ARKANSAS POWER & LIGHT COMPANY  
 POST OFFICE BOX 551 LITTLE ROCK, ARKANSAS 72203 (501) 371-4000

SUBJECT: Arkansas Nuclear One - Unit 1  
 Docket No. 50-313  
 License No. DPR-51  
 Degraded Grid Voltage  
 (File: 1510)

Subject: Arkansas Nuclear One-Units 1&2  
Docket Nos. 50-313, 50-368  
License Nos. DPR-51, NPF-6  
GDC-17, Millstone  
(File: 1510, 2-1510)

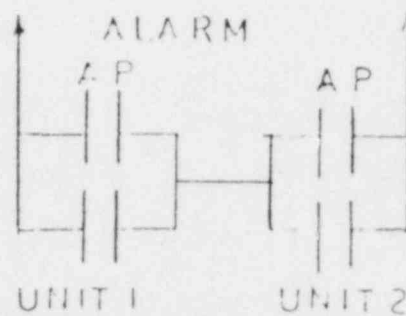
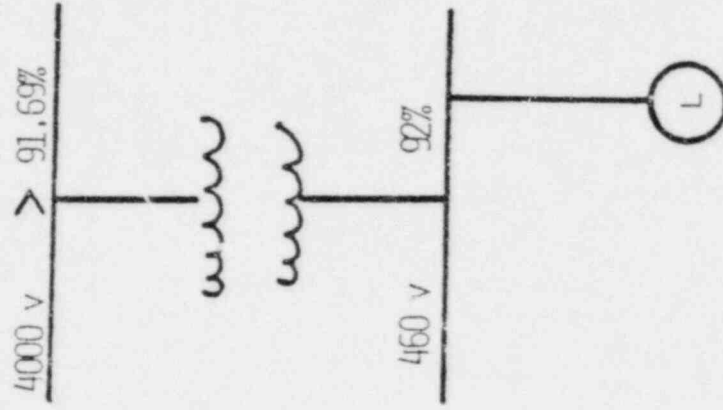
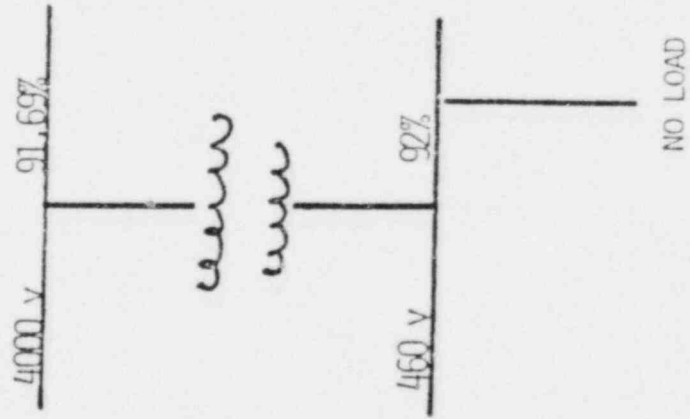
Item 5. An interlock between ANO-1, and ANO-2, and ST-2 has been proposed.

(a) Can the operation/maloperation/failure of any part of the interlock (including each sensor) cause both ANO-1 and ANO-2 loads to be applied to ST-2?

(b) Can the operation/maloperation/failure of any part of the interlock (including each sensor) prevent the manual loading of ANO-1 or ANO-2 ESF loads onto ST-2?

Response: Attachment VII shows our conceptual design for the interlocking mechanism. The interlock only affect the automatic portion of the system. Manual override is always available. The specific answer to each of the above items is "no."

1API, 2API N.O. CONTACTS IN SERIES WITH CLOSE AUTOMATIC TRANSFER LEG OF EACH BREAKER IN UNIT TWO.

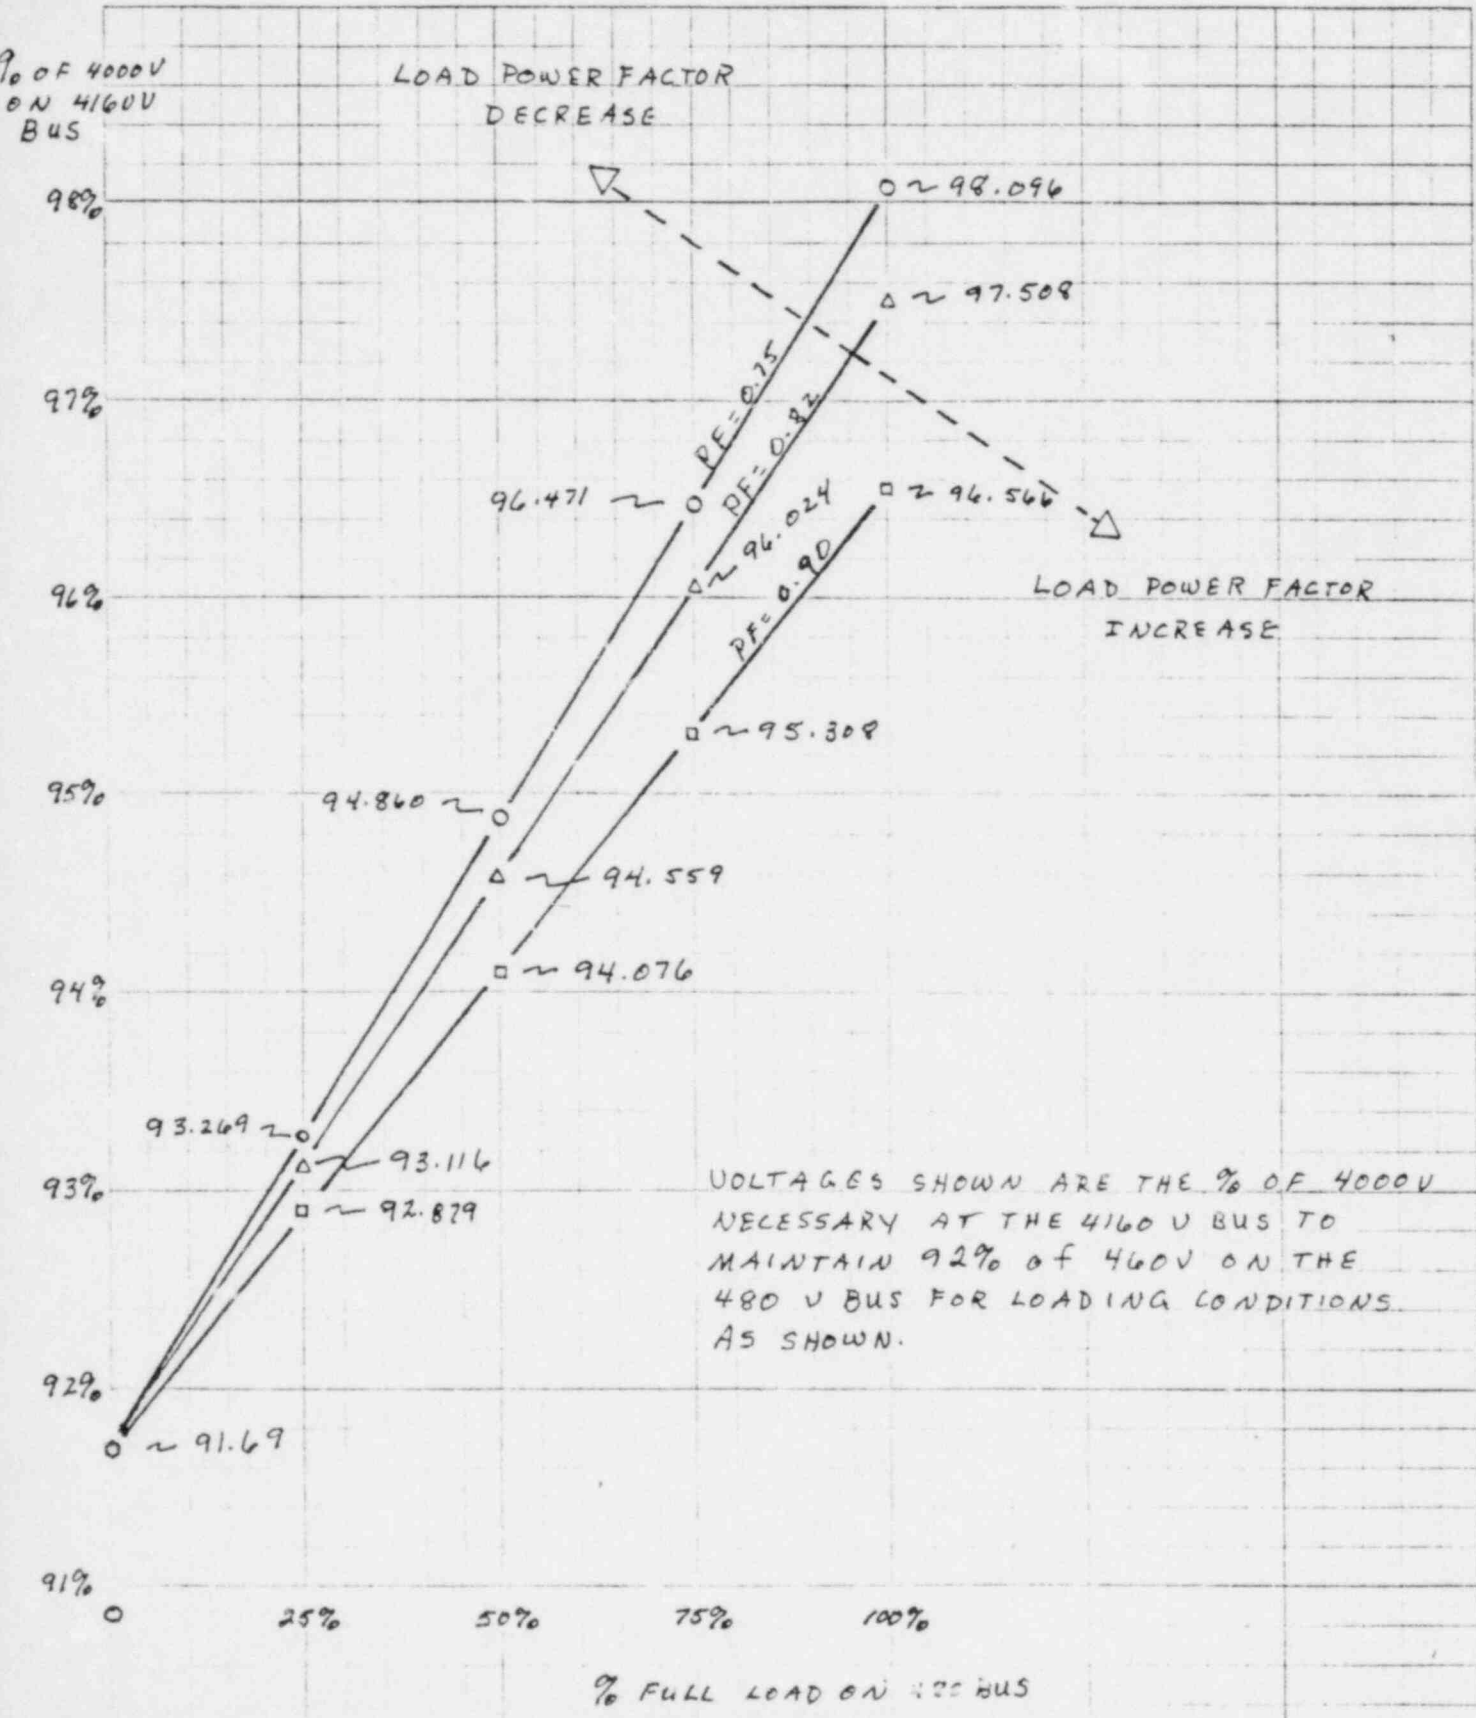
Item 6. What is the equivalent undervoltage setpoint at the 4160V buses coordinated with your proposed setpoint at a value of 92% of rated voltage on the 480V buses?

Response: With no load on the 480V bus, the voltage on the 4160V bus necessary to maintain 92% of 460V on the 480V bus, is 91.69% of 4000V. As the load is increased on the 480V, the voltage on the 4160V bus must increase to maintain 92% of 460V on the 480V bus. This is shown on Attachment IX.
